# HISTORIC AND DESIGN REVIEW COMMISSION

March 05, 2025

**HDRC CASE NO:** 2025-038  
**ADDRESS:** 109 W GRAYSON ST  
**LEGAL DESCRIPTION:** NCB 7006 BLK A LOT 10& LOTS 11 & 12  
**ZONING:** C-3, RIO-2  
**CITY COUNCIL DIST.:** 1  
**APPLICANT:** Sinuhe Maldonado Jr/Sol Studio Architects, LLC  
**OWNER:** Doug Ackerly/S B J ENTERPRISES INC  
**TYPE OF WORK:** Exterior modifications, construction of a rooftop addition, fenestration modifications, fencing  
**APPLICATION RECEIVED:** February 14, 2025  
**60-DAY REVIEW:** April 15, 2025  
**CASE MANAGER:** Edward Hall  
**REQUEST:**

Re: 109 W Grayson Building Renovation at 109 W Grayson St. San Antonio Texas –  
Submittal Request for Certificate of Appropriateness

**1** **PROPOSED NEW CONSTRUCTION PLAN - ROOF-TOP PATIO**

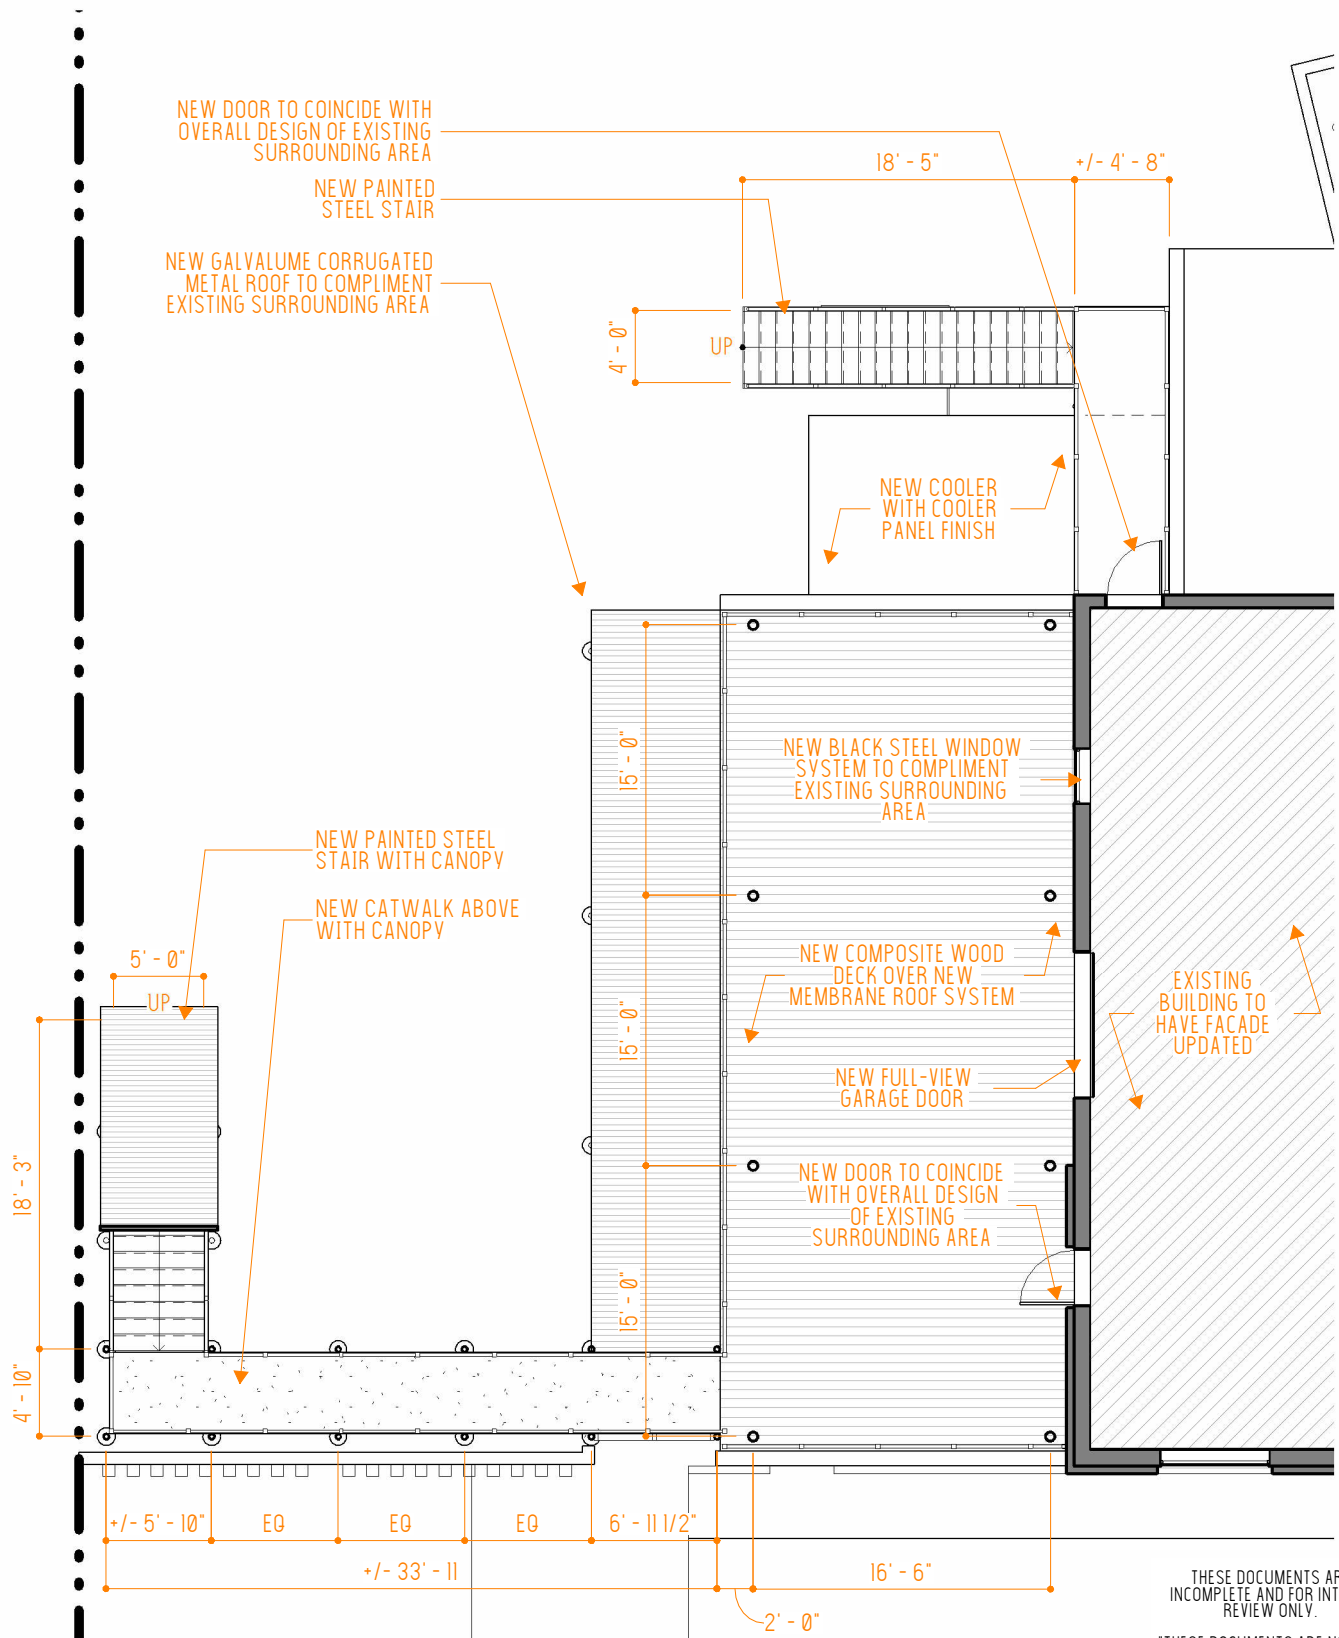
- b. ROOFTOP PATIO ADDITION – The applicant has proposed to construct a rooftop patio addition to feature a steel structure, stairs, a shade canopy, a walk-in cooler, and an elevated walkway. The proposed addition will be constructed atop the one-story portion of the existing structure. Generally, staff finds the proposed massing, materials, and design elements to be appropriate and consistent with the UDC Section 35-674.

- 1. Staff recommends approval of item #1, the construction of a rooftop patio addition, stairs, a shade, canopy, walk-in cooler, and an elevated walkway, based on finding b, as submitted.

## PROPOSED NORTH ELEVATION - MATCHLINE A

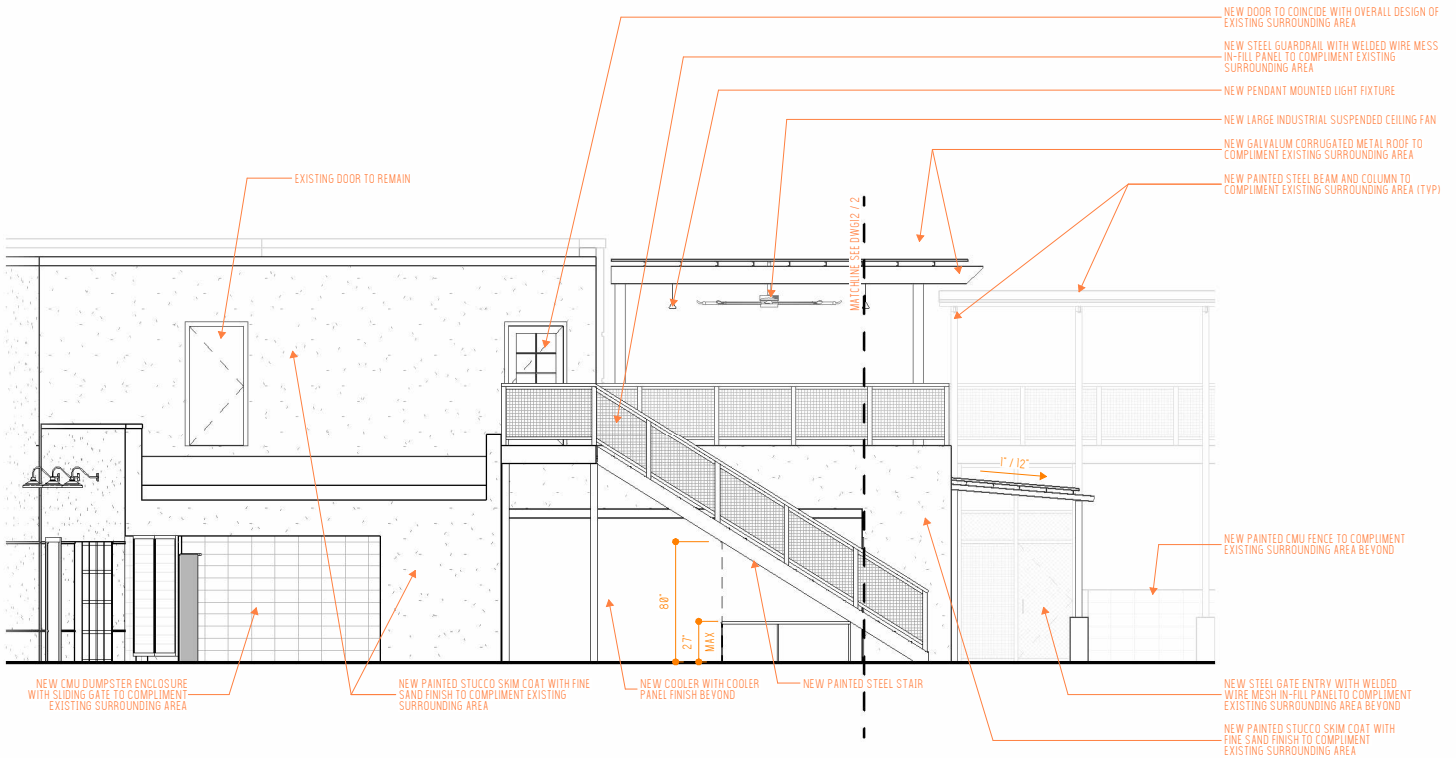
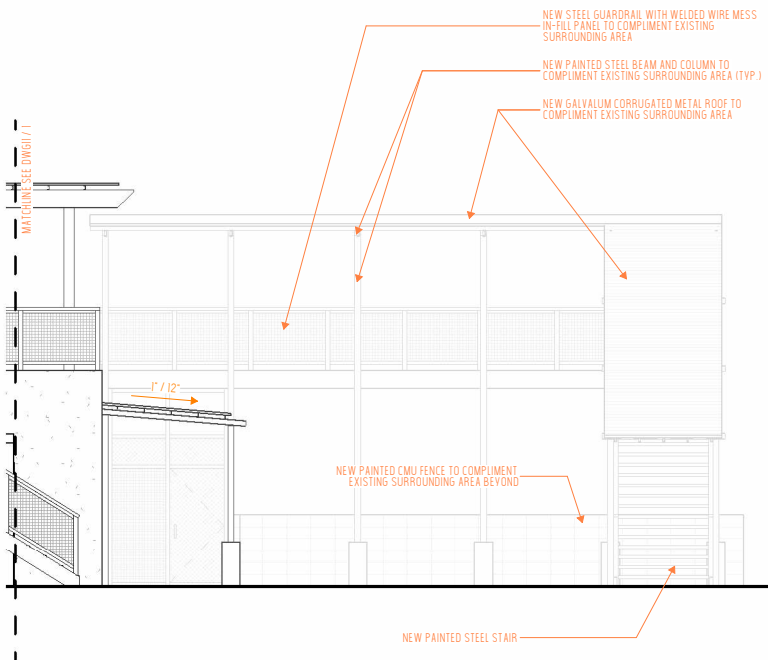
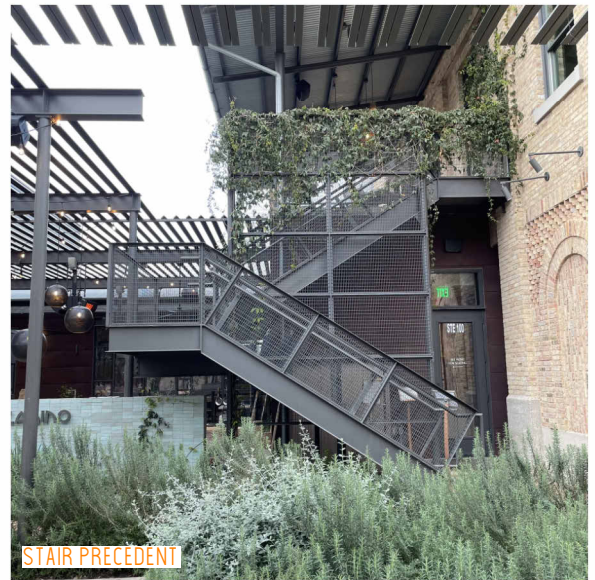
- c. FAÇADE MODIFICATIONS (Materials) – The applicant has proposed to clad the existing structure’s façade in brick, textured stucco, and pre-finished metal siding. Currently, the structure features a stucco/plaster façade. Generally, finds the proposed materials to be appropriate and consistent with the UDC Section 35-674(d).

- d. FENESTRATION MODIFICATIONS – The applicant has proposed a number of fenestration modifications including the installation of new window openings and door openings on each façade. Generally, staff finds the proposed window and door modifications to be appropriate and to be in keeping with the structure’s original fenestration pattern. The applicant has noted that the new windows will be black steel windows.

- e. WINDOW REPLACEMENT – The applicant has proposed to replace the existing, aluminum windows with black steel windows. Staff finds window replacement to be appropriate and finds the steel materials to be appropriate; however, staff finds that the proposed windows should not feature faux divided lites and should be installed at least two (2) inches within openings, as noted in the UDC Section 35-674(e)(2)(A).

- 2. Staff recommends approval of item #2, the cladding of the exterior of the existing structure in brick, textured stucco, and pre-finished metal siding, based on finding c, as submitted.

- 3. Staff recommends approval of item #3, fenestration modifications and the replacement of existing aluminum windows, based on findings d and e with the following stipulations:

- i. That the proposed windows do not feature faux divided lites.
  - ii. That all windows be installed at least two (2) inches within openings.
- 4. Staff recommends approval of item #4, the installation of brick pavers and a dumpster enclosure based on finding f, as submitted.

**1 PROPOSED SITE PLAN**  
1" = 20'-0"

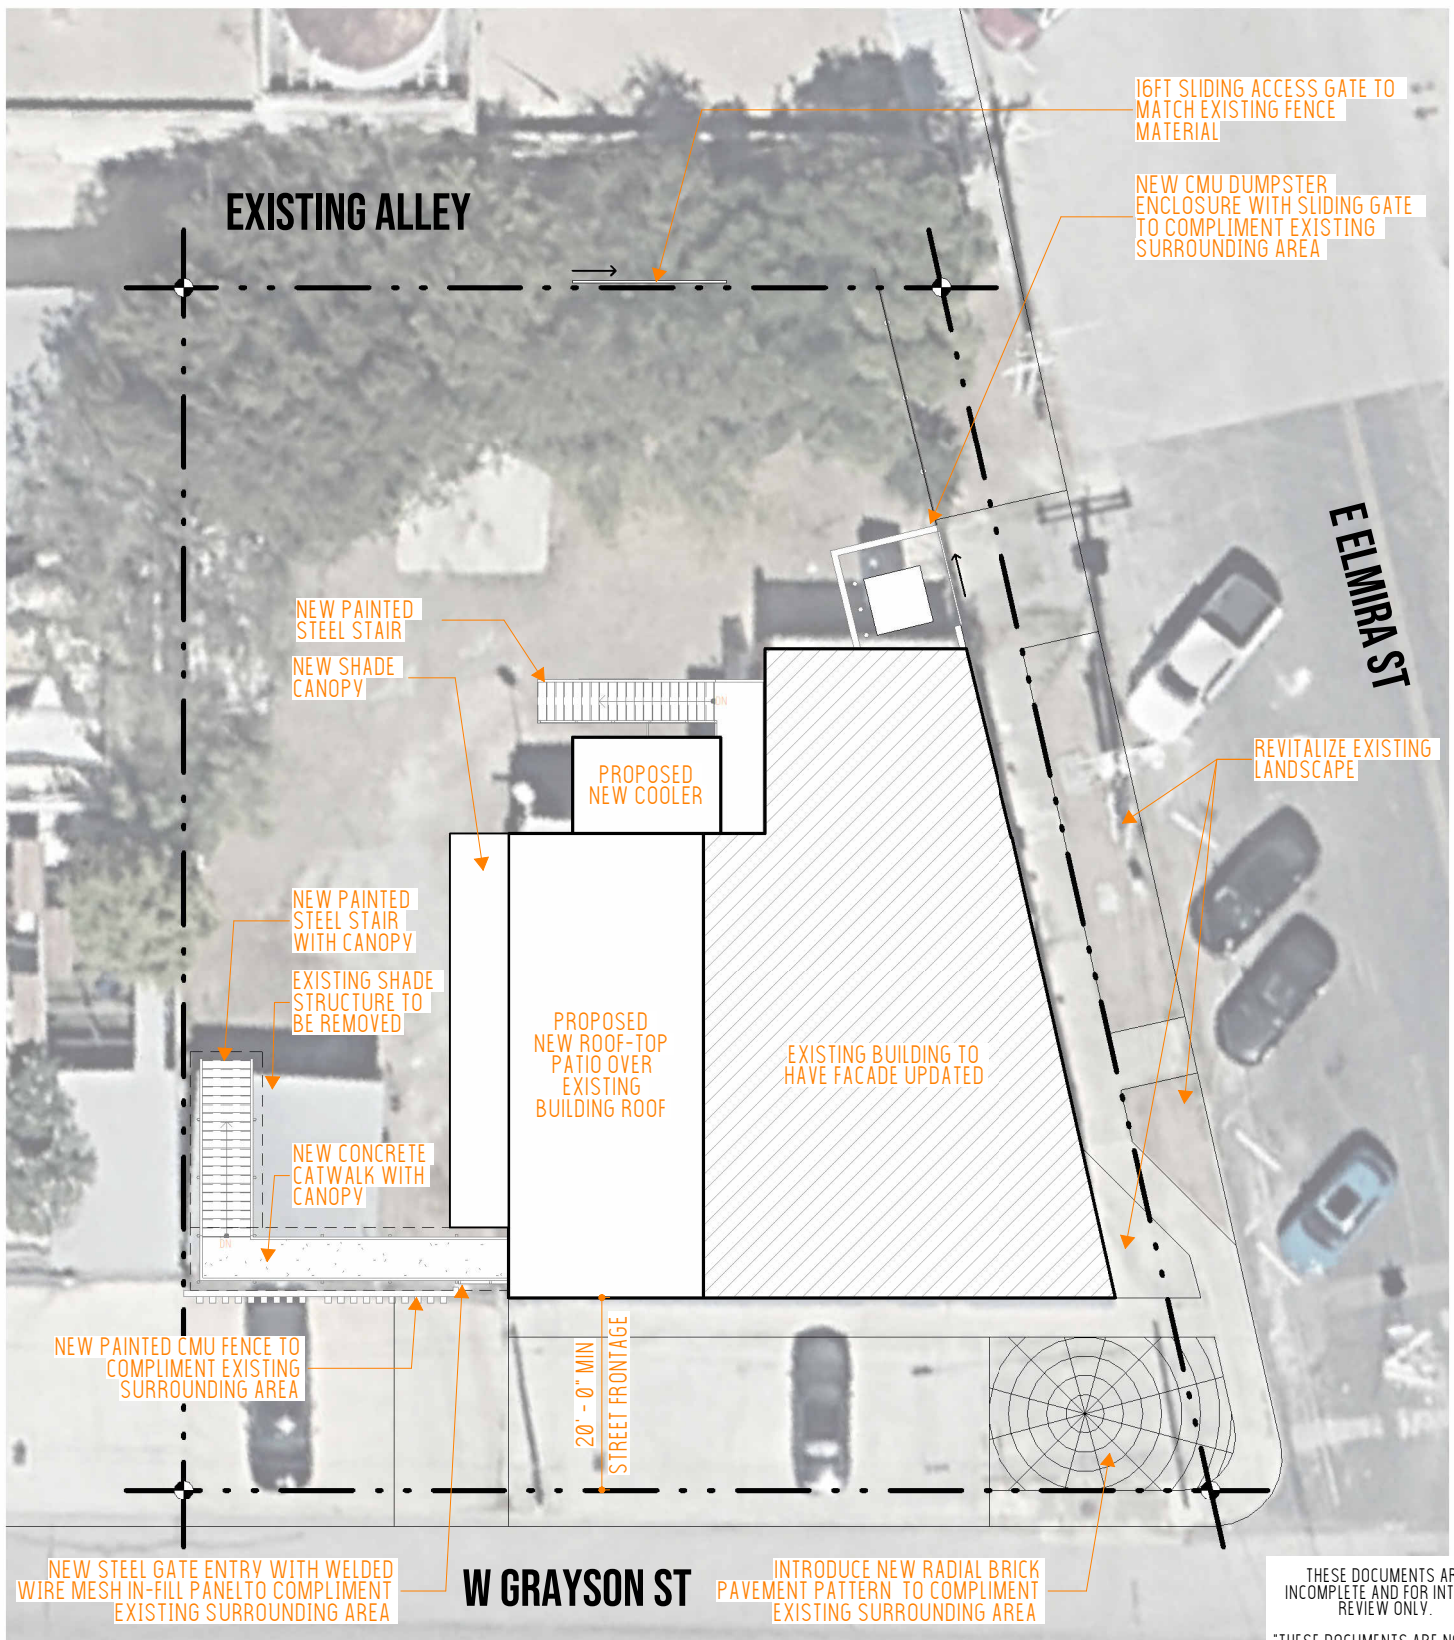
- f. SITE MODIFICATIONS – The applicant has proposed a number of site modifications including the installation of brick pavers at the southeast corner of the property, and the installation of a dumpster pad and enclosure at the rear of the site, facing E Elmira. Generally, staff finds the proposed location of the dumpster pad and enclosure to be appropriate as it is not located on the primary street and features materials that are complementary of those of the main structure; however, staff finds that the proposed CMU wall should feature an architectural bond pattern and be painted or feature a stucco/plaster finish as CMU’s are prohibited in the River Improvement Overlay by the UDC. The applicant has submitted a detailed information regarding the wall’s stack pattern and finish, which staff finds to be appropriate.

- g. CMU WALL – The applicant has proposed to construct a CMU wall to run parallel to the right of way along W Grayson Street. As noted in finding f, staff finds that the proposed wall should feature an architectural bond pattern and be painted or feature a stucco/plaster finish as CMU’s are prohibited in the River Improvement Overlay by the UDC. The applicant has submitted a detailed information regarding the wall’s stack pattern and finish, which staff finds to be appropriate.

- 5. Staff recommends approval of item #5, the construction of a wall parallel to the right of way along W Grayson, based on finding g, as submitted.
